SUBJECT: LASALLE COUNTY STATION, UNITS 1 AND 2 - ISSUANCE OF  
AMENDMENTS (TAC NOS. MA8403 AND MA8404)

The amendments revise the pressure-temperature (P-T) limits for heatup, cooldown, critical operation and inservice leak and hydrostatic test limitations for the reactor pressure vessel (RPV). The amendments replace the current RPV P-T limit curves with three recalculated curves that are applicable to 32 effective full power years. The staff has approved the revised limits for an interim period not to exceed December 15, 2002.

SAFETY EVALUATION BY THE OFFICE OF NUCLEAR REACTOR REGULATION  
RELATED TO AMENDMENT NO. 144 TO FACILITY OPERATING LICENSE NO. NPF-11  
AND AMENDMENT NO. 130 TO FACILITY OPERATING LICENSE NO. NPF-18  
COMMONWEALTH EDISON COMPANY  
LASALLE COUNTY STATION, UNITS 1 AND 2  
DOCKET NOS. 50-373 AND 50-374

Figure 3.4.6.1-1

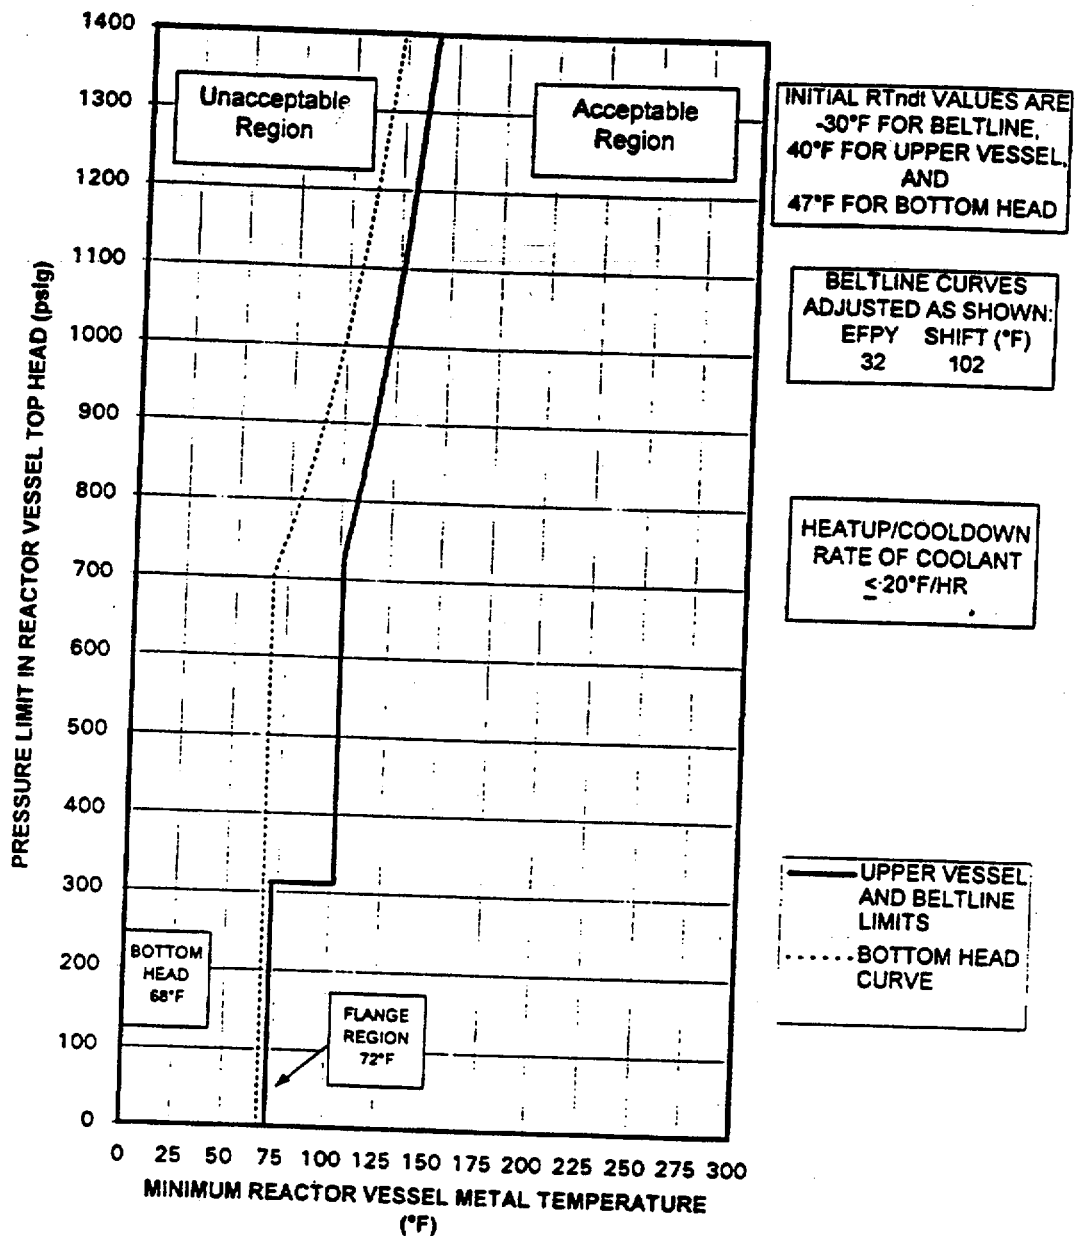
3.4.6.1 The reactor coolant system temperature and pressure shall be limited in accordance with the limit lines shown on Figure 3.4.6.1-1 for hydrostatic or leak testing; Figure 3.4.6.1-1a for heatup by non-nuclear means, cooldown following a nuclear shutdown and low power PHYSICS TESTS; and Figure 3.4.6.1-1b for operations with a critical core other than low power PHYSICS TESTS, with:

4.4.6.1.3 The reactor vessel material specimens shall be removed and examined to determine reactor pressure vessel fluence as a function of time and THERMAL POWER as required by 10 CFR Part 50, Appendix H. The results of these fluence determinations shall be used to update the curves of Figures 3.4.6.1-1, 3.4.6.1-1a, and 3.4.6.1-1b.

Figure 3.4.6.1-1

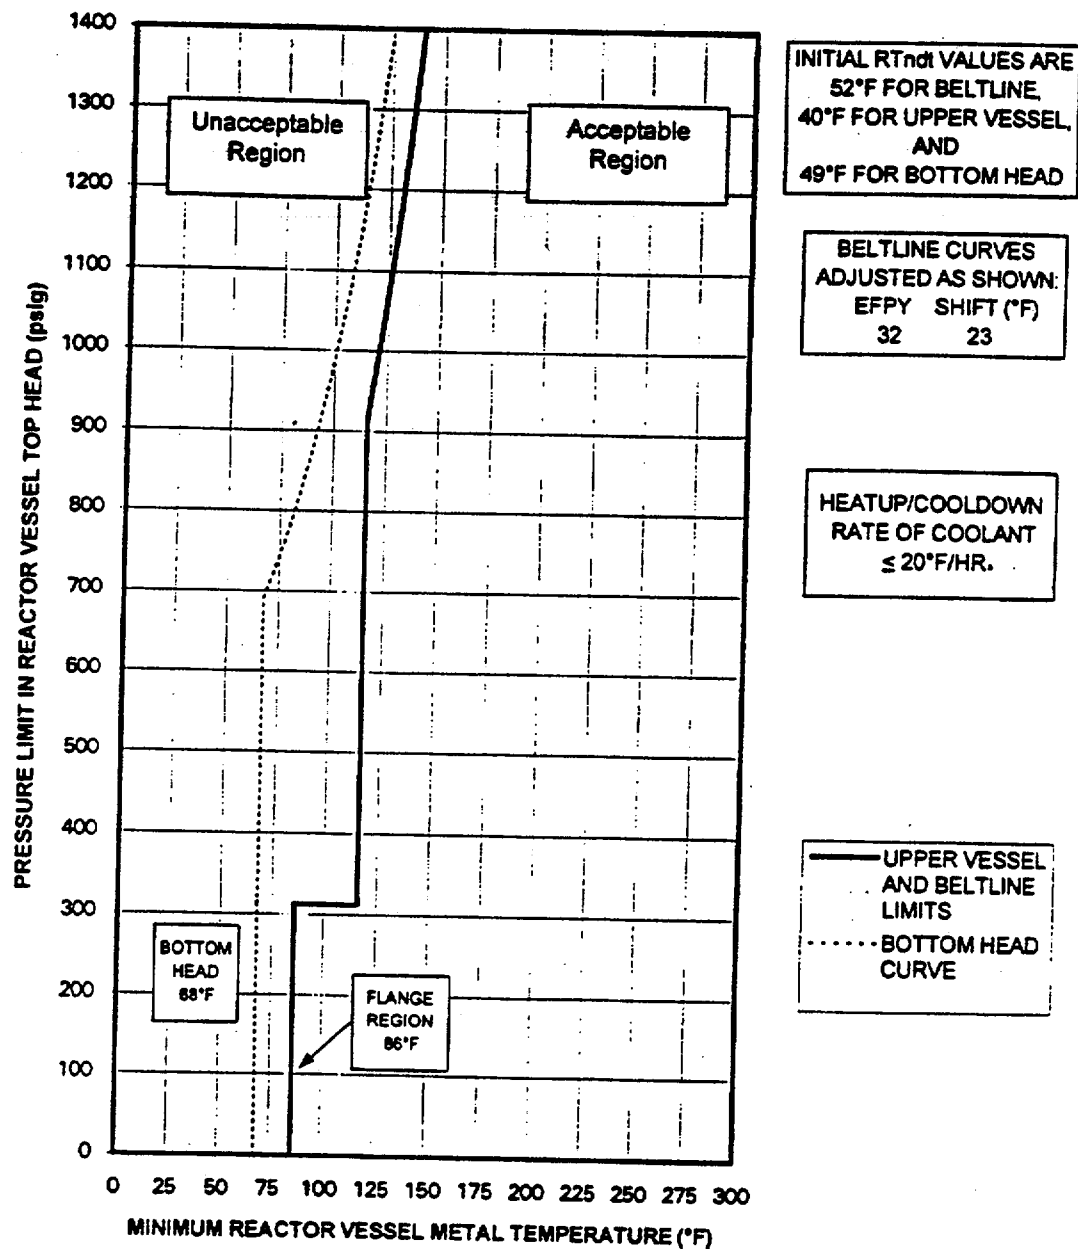
3.4.6.1 The reactor coolant system temperature and pressure shall be limited in accordance with the limit lines shown on Figure 3.4.6.1-1 for hydrostatic or leak testing; Figure 3.4.6.1-1a for heatup by non-nuclear means, cooldown following a nuclear shutdown and low power PHYSICS TESTS; and Figure 3.4.6.1-1b for operations with a critical core other than low power PHYSICS TESTS, with:

4.4.6.1.3 The reactor vessel material specimens shall be removed and examined to determine reactor pressure vessel fluence as a function of time and THERMAL POWER as required by 10 CFR Part 50, Appendix H. The results of these fluence determinations shall be used to update the curves of Figures 3.4.6.1-1, 3.4.6.1-1a, and 3.4.6.1-1b.
